**KRISTY PETERKIN**  
**SCHEME RANKING**  
 APS: New Elementary School at Reed

Rank from 1 (Favorite)  
 to 6 (Least Favorite)

#### Integrated Scheme

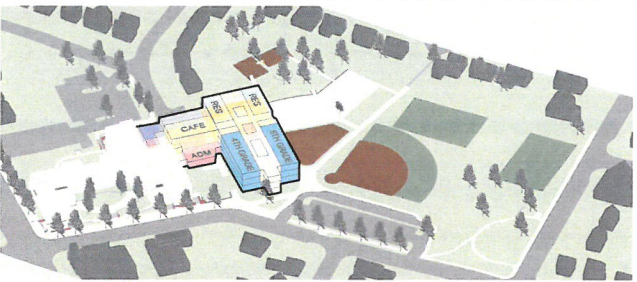
Integrated because

- builds up - 4 stories is key
- prevents half-baked heavy-up decision
- compact, preserves much of open space

#### Integrated Scheme

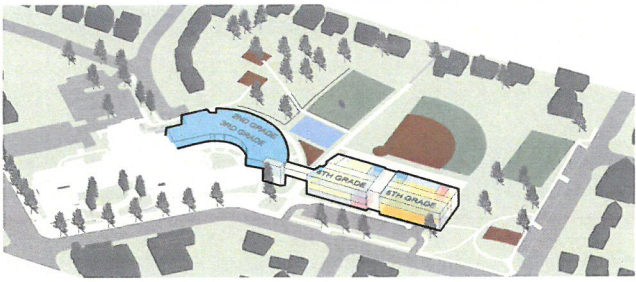
Integrated more closely follows the Civic Design principles of PFRC. Its Much more efficient from an educational, & energy savings, <sup>benefit</sup>

### Integrated Scheme

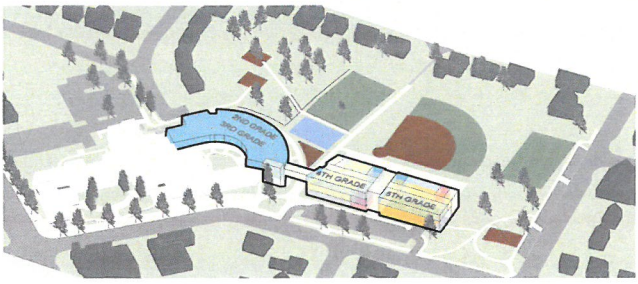
*do 4 stories*

#### Integrated Scheme

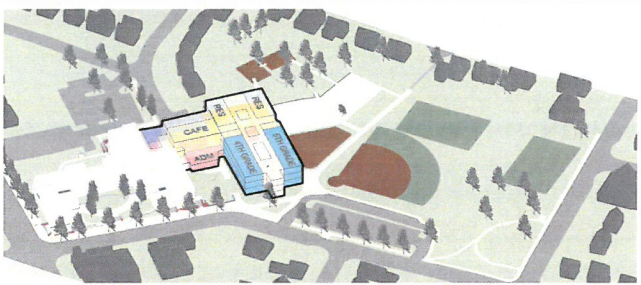
*-4 stories*

- 1) Integrated - Best for urban design as it puts density closest to Washington Blvd and its activity. Leaves open space between commercial activity and residential area. Preserves most open space.
- 2) Bridge - ~~Preserves~~ Preserves open space and uses original building.
- 3) Upper Lower - Has advantage of extra potential capacity.
